INSTALLATION OF CUSHION BARRIER
AT LUNALILO FRWY - VINEYARD (OFF-RAMP)
& STA. 83+00
SAFETY IMPROVEMENTS ALONG
INTERSTATE H-1
KALIHI ST. TO PALI HIGHWAY
Proj. No. I-HI-1(112):19 Date: April, 1973

STATE OF HAWAII
DEPARTMENT OF TRANSPORTATION
HIGHWAYS DIVISION
INSTALLATION OF CUSHION BARRIER
AT LUNALILO FRWY. & RAMP "5"
@ Sta. 103+50
SAFETY IMPROVEMENTS ALONG
INTERSTATE H-1
KALIHI ST. TO PALI HIGHWAY
Proj. No. I-H-1(112)19 DATE: April, 1973

C. O. 45

SAFETY IMPROVEMENTS ALONG
INTERSTATE H-1
KALIHI ST. TO PALI HIGHWAY

SHEET No. 60 OF 110 SHEETS

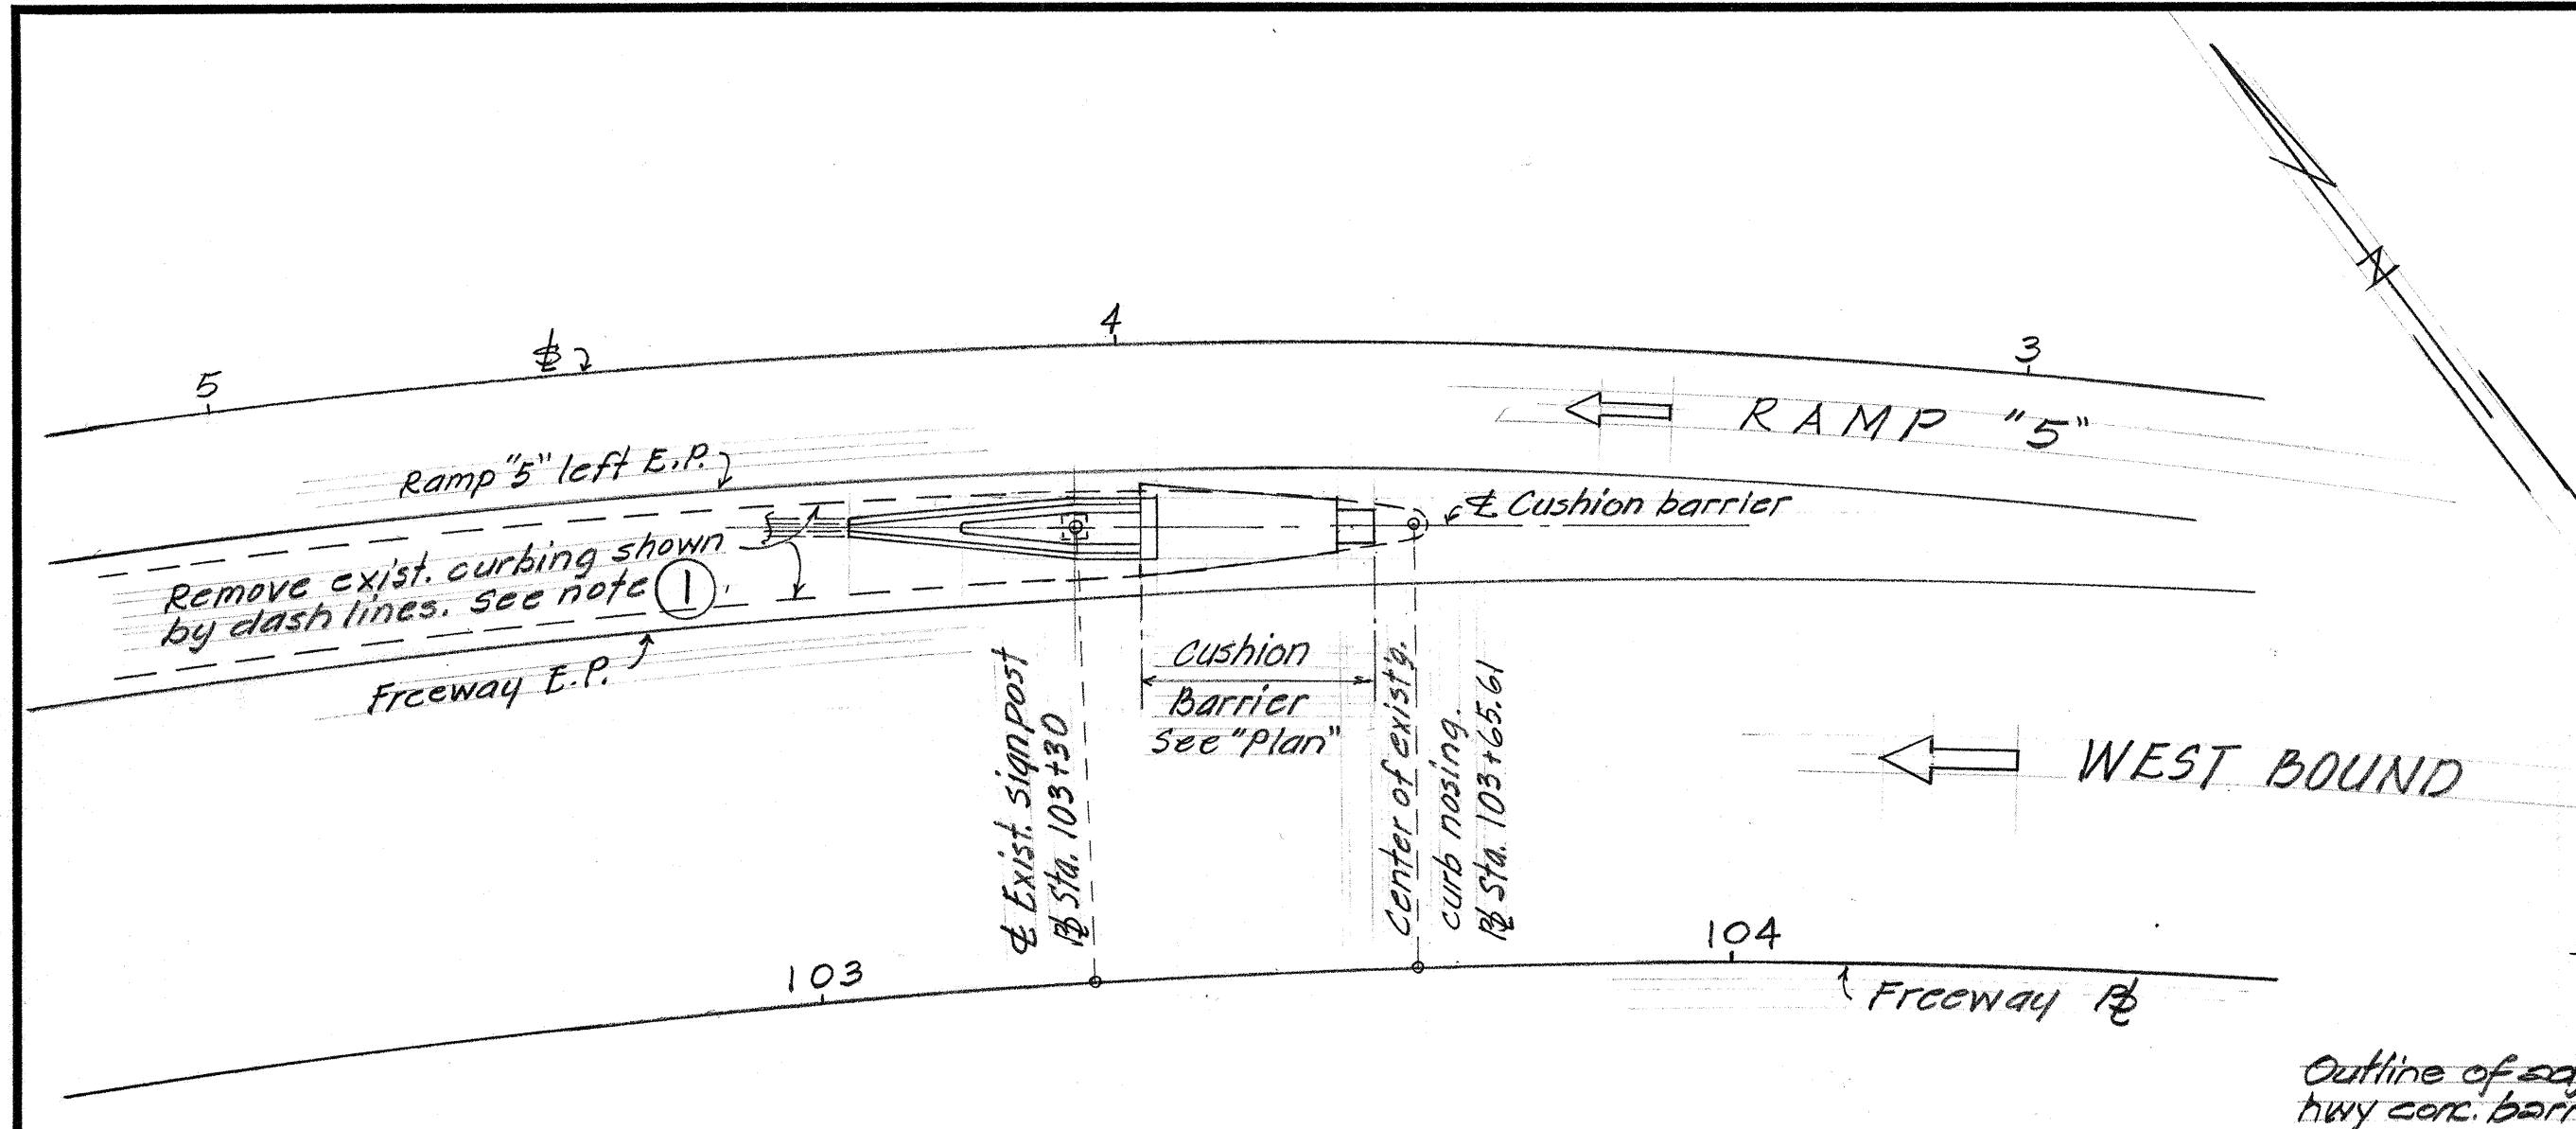
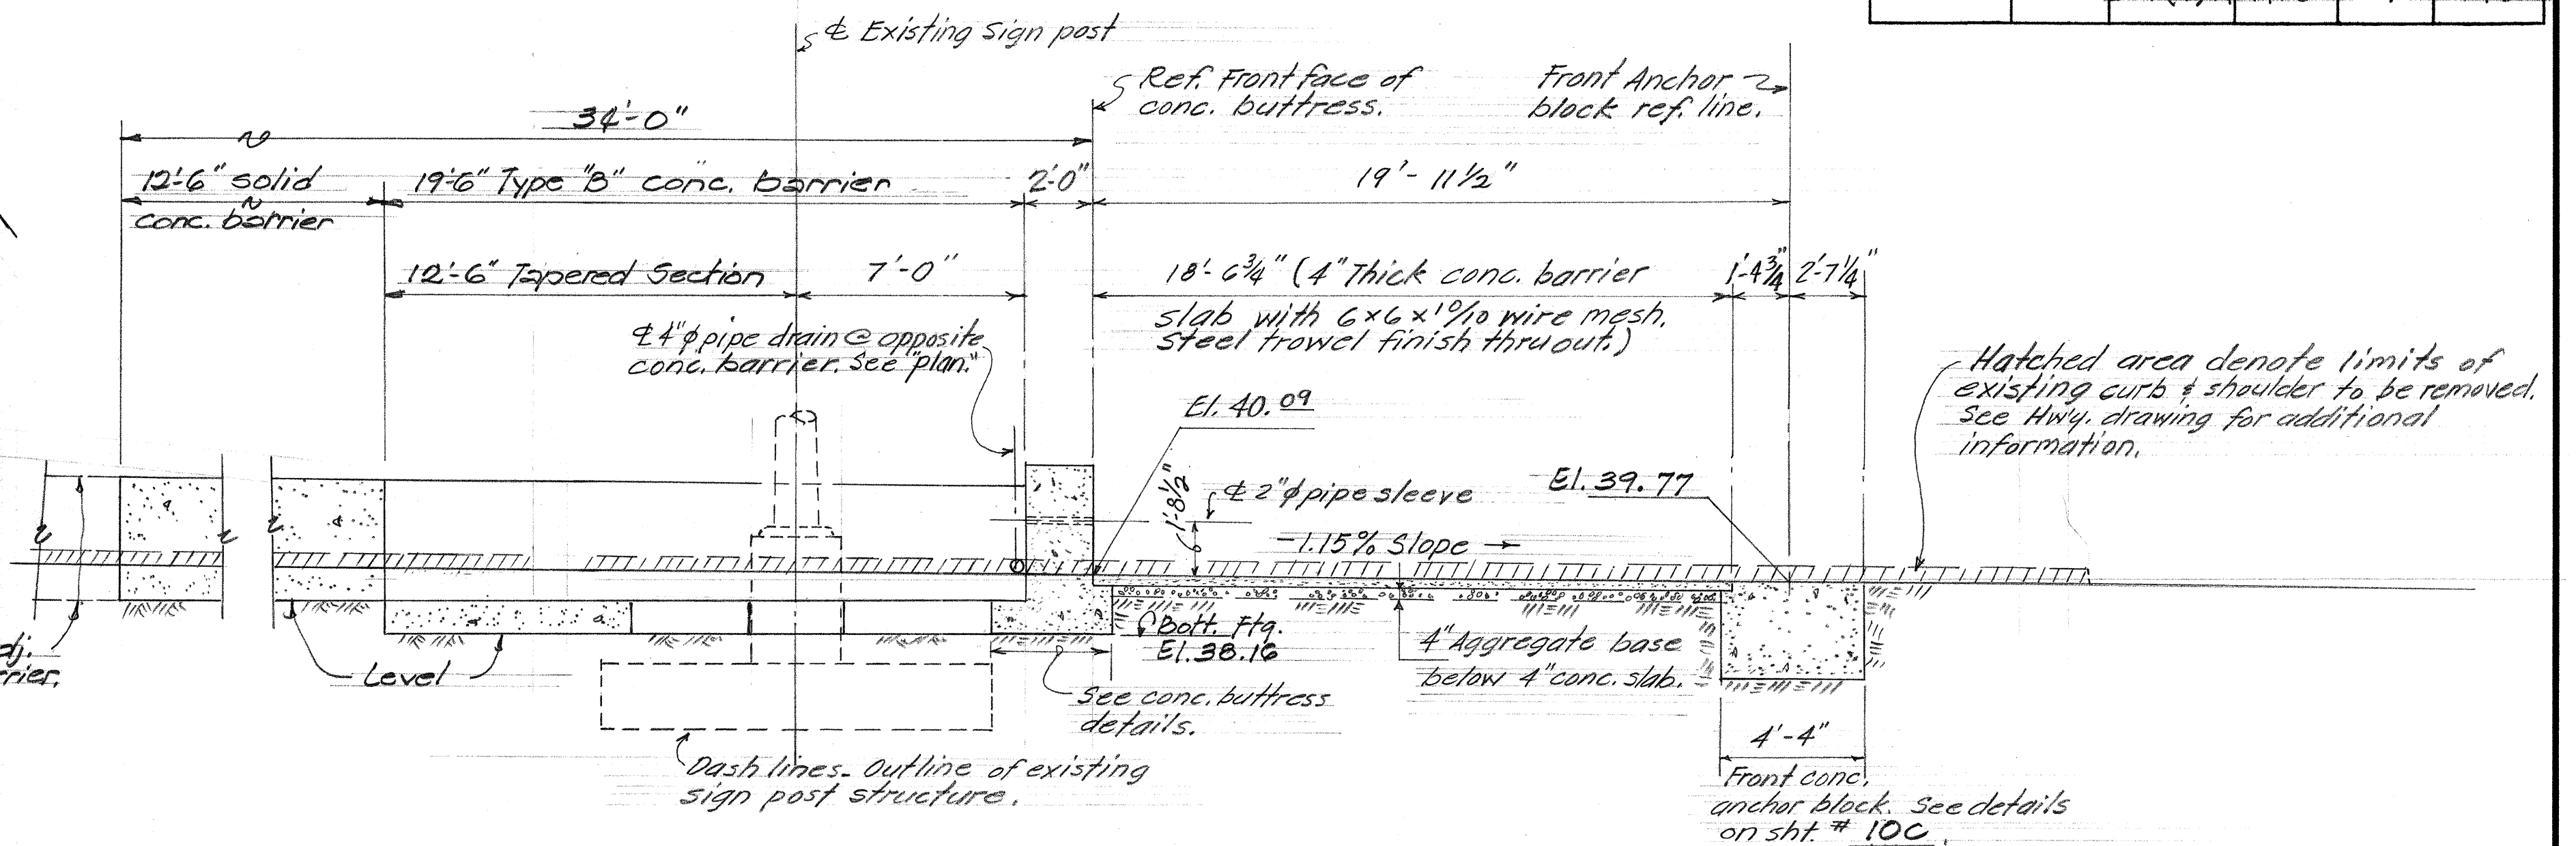
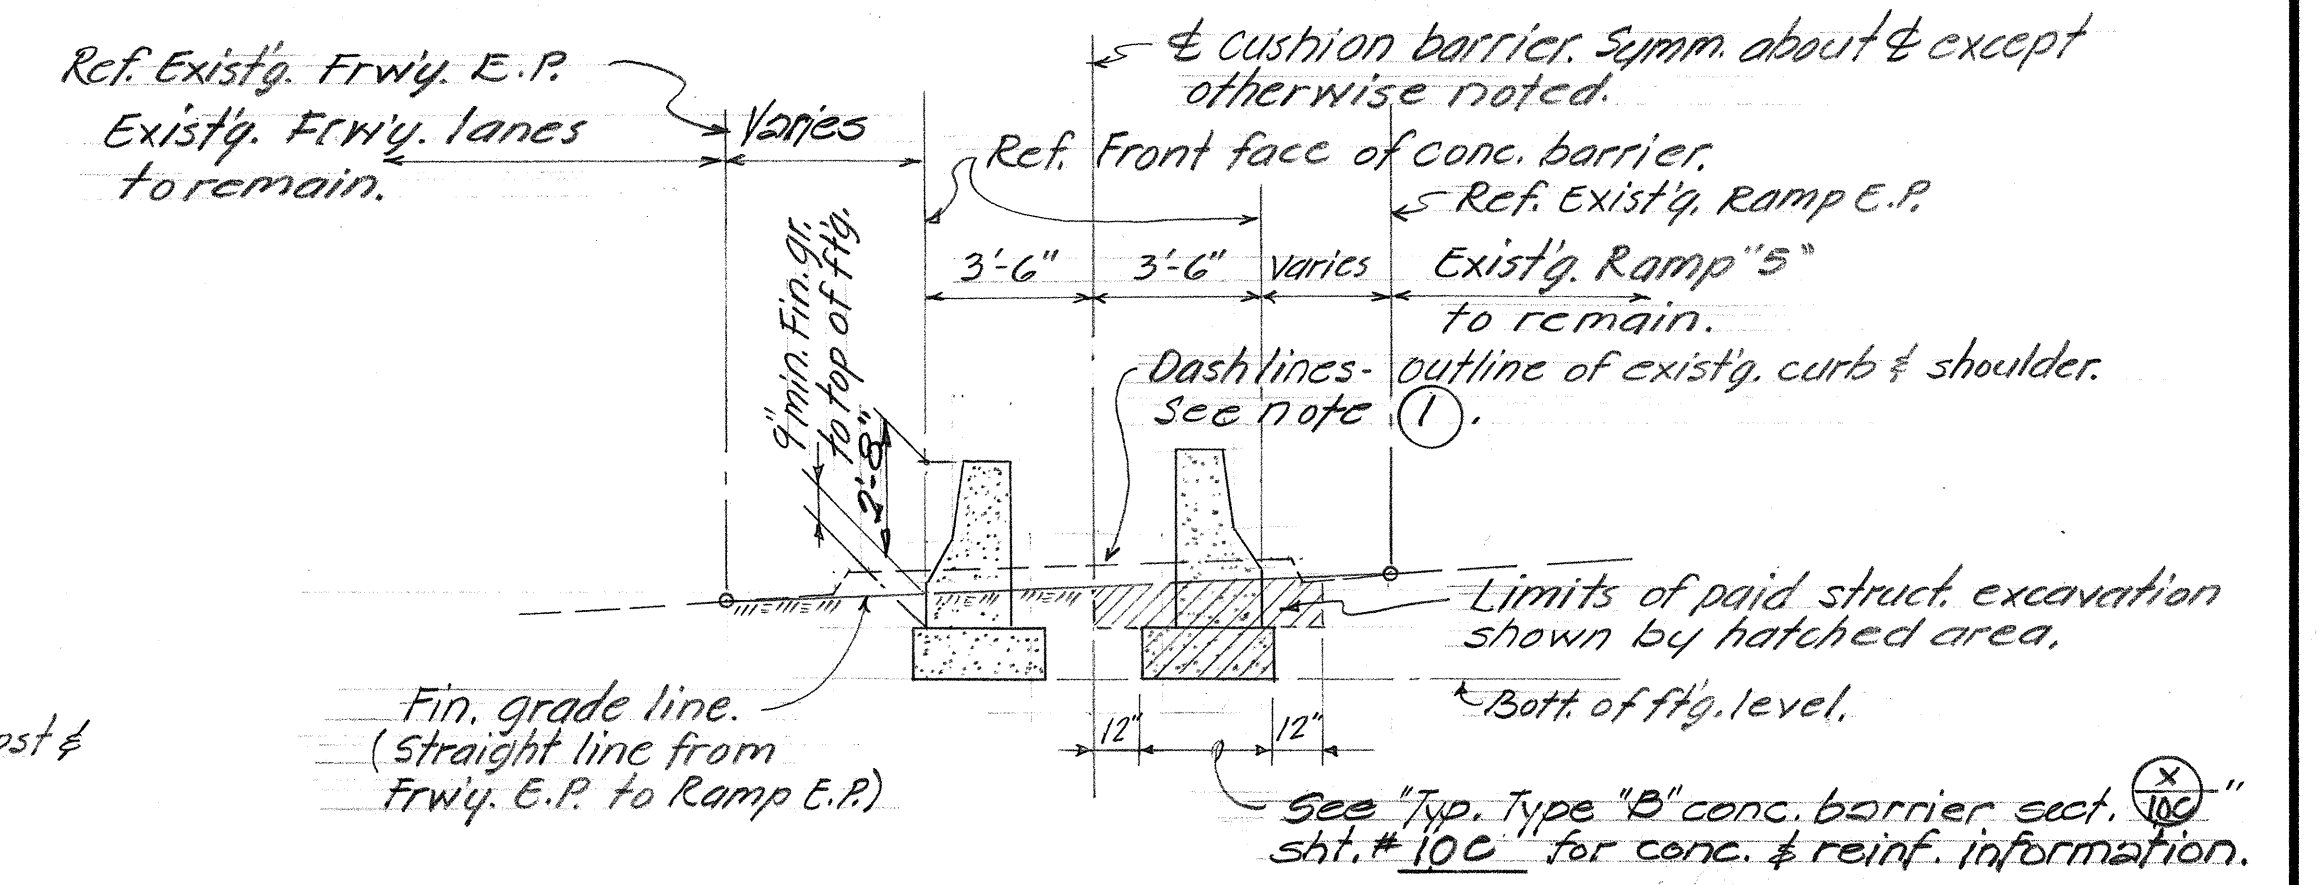
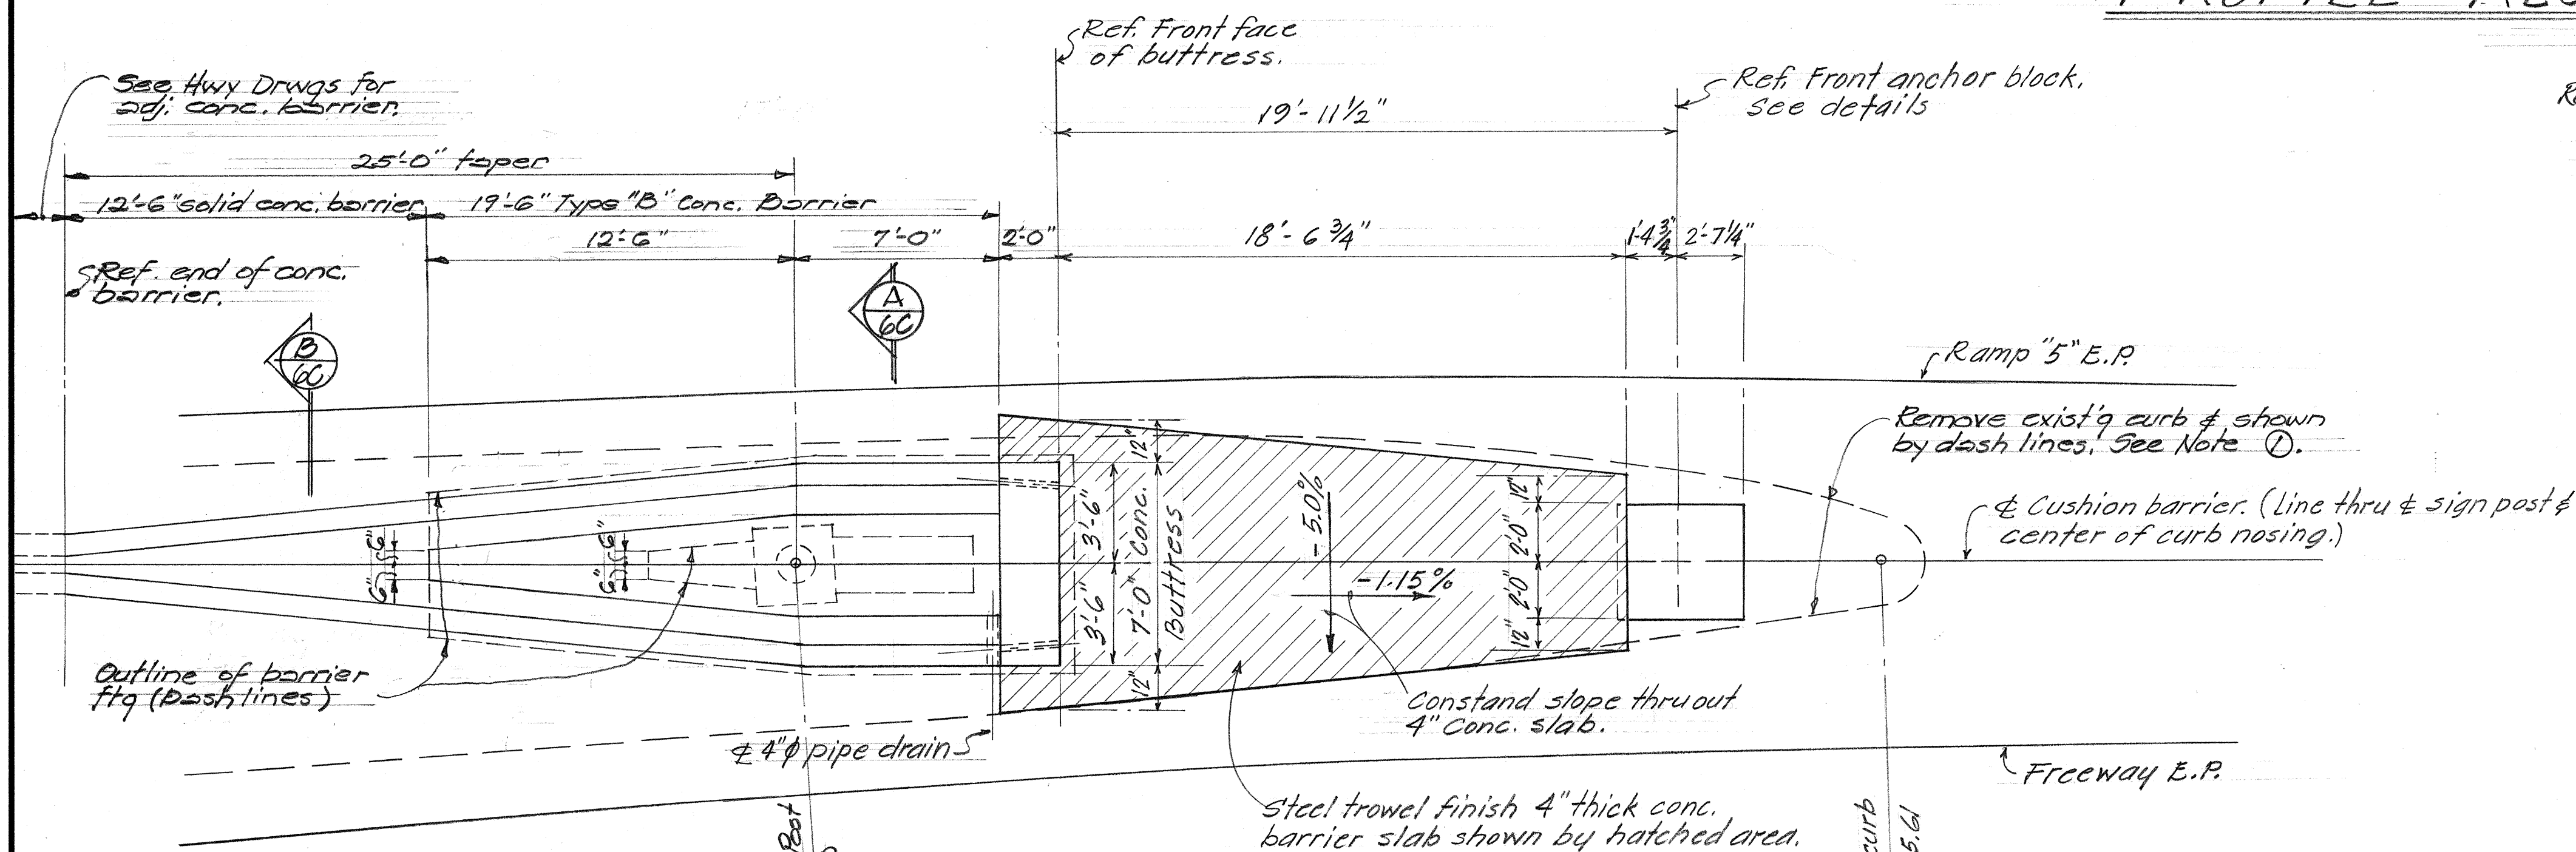
12'-6-74 Height of 2" pipe sleeve changed from 1'-8" to 1'-8 1/2" and length of unit changed from 21'-2 1/4" to 19'-11 1/2".
